**LIGHTNING**

# SERVICE BULLETIN No.006

<b>PRODUCT MODEL</b>	: CCS Lightning
<b>BULLETIN TYPE</b>	: Product Testing
<b>MANUAL / SECTION</b>	: N/A
<b>PARTS LIST REVISION</b>	: N/A
<b>EFFECTIVE DATE</b>	: June 27, 2006
<b>SUBJECT</b>	: <b>HVAC Performance Evaluation Procedure</b>
<b>UNITS AFFECTED</b>	: S/N < 61499999
<b>PARTS AFFECTED</b>	: N/A
<b>TERMS &amp; CONDITIONS</b>	: N/A

Figure 1

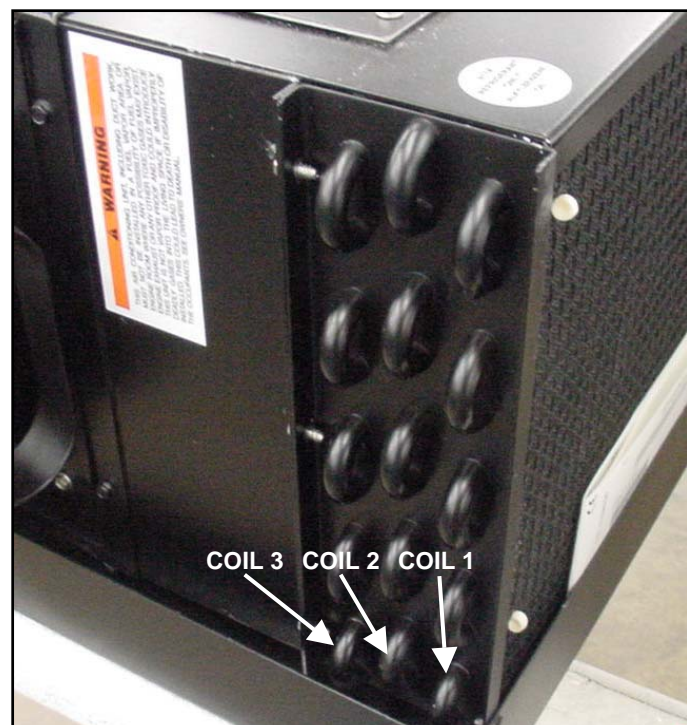
1. Turn unit on in COOL mode; allow to operate for five minutes.
2. After five minutes, look for the following:
  - a. On the **10K unit**, the return bends on the evaporator coil should be cold and sweaty all the way up the coil (Fig. 1)
  - b. On the **14K unit**, the coil circuitry is a little different. The return bends should be checked for saturation height (**All three coils should be sweaty to equal heights**); as well as making sure each of the three circuits is active (Fig. 2). The return bends should be cold and sweaty all the way up the coil (Figure 1.)
3. The unit should have at least 15°F (8°C) differential from intake at the coil to discharge grill with the Fan on high.

The CHEB units cooling capacity is in question due to possible capillary tube defect. Please perform the test (see next page) and if the unit fails to meet criteria #2 and #3, the CHEB should be replaced.
